HISTORIC AND DESIGN REVIEW COMMISSION

May 02, 2018

HDRC CASE NO: 2018-200
ADDRESS: 119 GORMAN ST
LEGAL DESCRIPTION: NCB 1666 BLK J LOT 10
ZONING: R-5, H
CITY COUNCIL DIST.: 2
DISTRICT: Dignowity Hill Historic District
APPLICANT: David Bolton Travis Linares
OWNER: David Bolton Travis Linares
TYPE OF WORK: Construction of a rear addition, exterior modifications and Historic Tax Certification
APPLICATION RECEIVED: April 13, 2018
60-DAY REVIEW: June 12, 2018
REQUEST:

Rear View

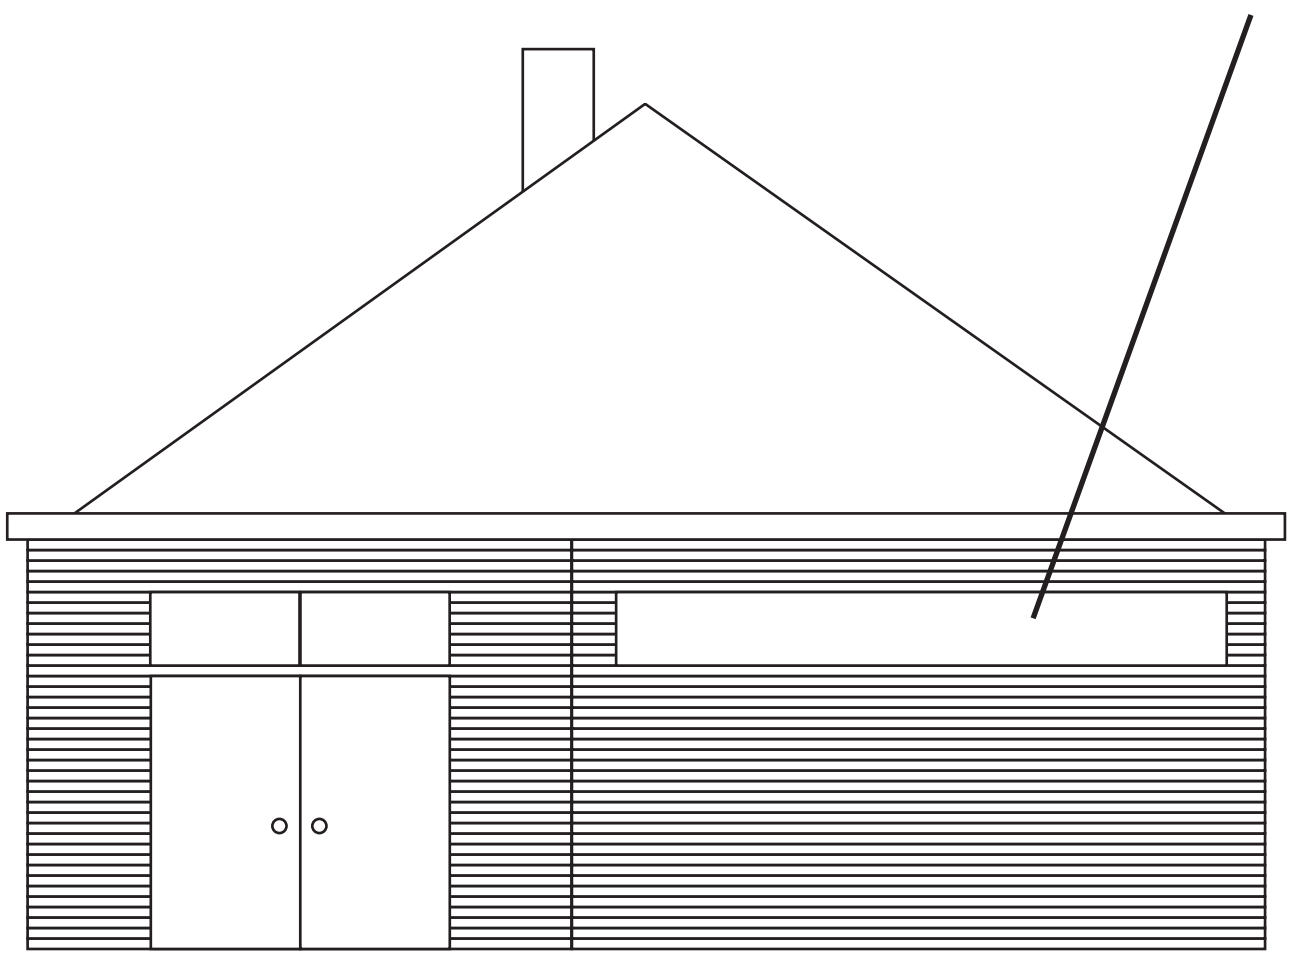
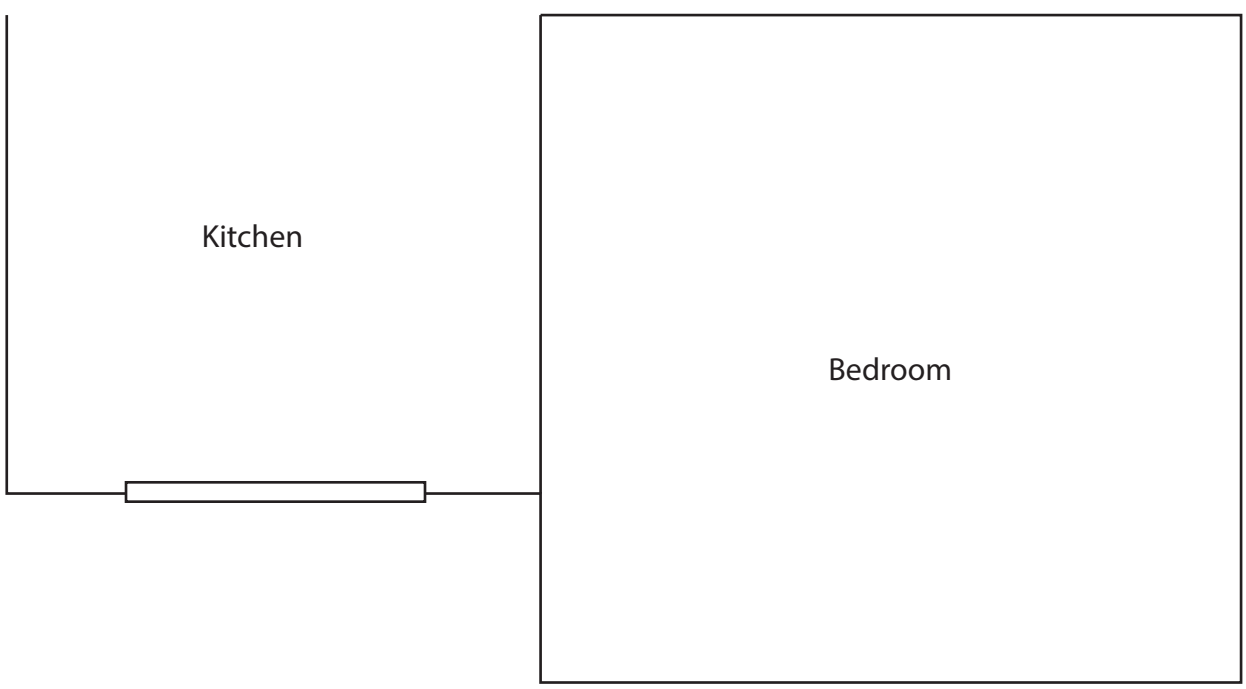
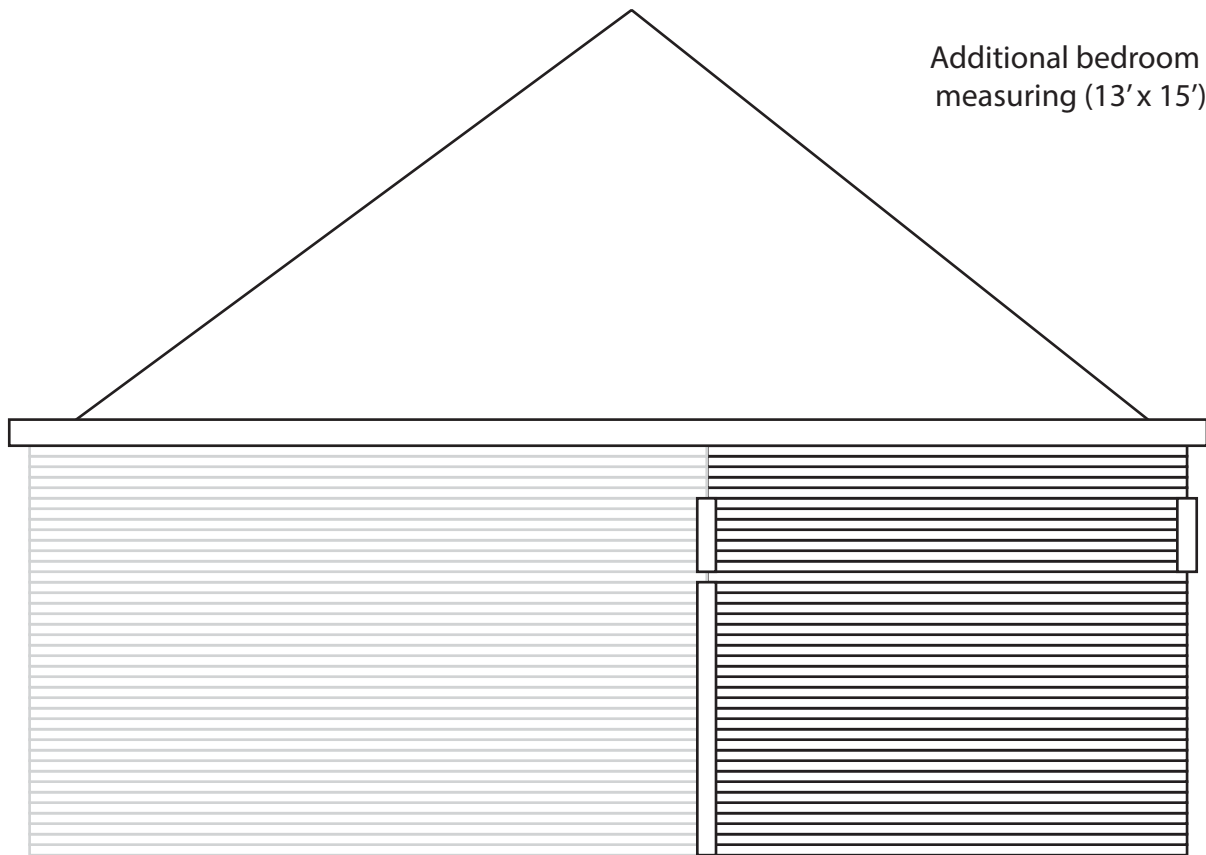
- j. ADDITION – The applicant has proposed to construct a rear addition to feature approximately 195 square feet. The applicant has proposed a roof form to match that found on the existing addition, wood siding to match that found on the existing addition and a matching foundation height. Staff finds the proposed massing and roof form to be appropriate.

- k. ADDITION – The applicant has proposed to install a window on the rear façade to feature a total width of approximately eight feet and a height of approximately ten inches. While this profile is not found historically in the district, staff finds that it's location at the rear of the structure is appropriate.

5. Staff recommends approval of item #5, the installation of French doors in the existing addition.
6. Staff recommend approval of item #6, the construction of a rear addition with the stipulation that all siding match that of the original structure and that the roof match that of the existing addition's
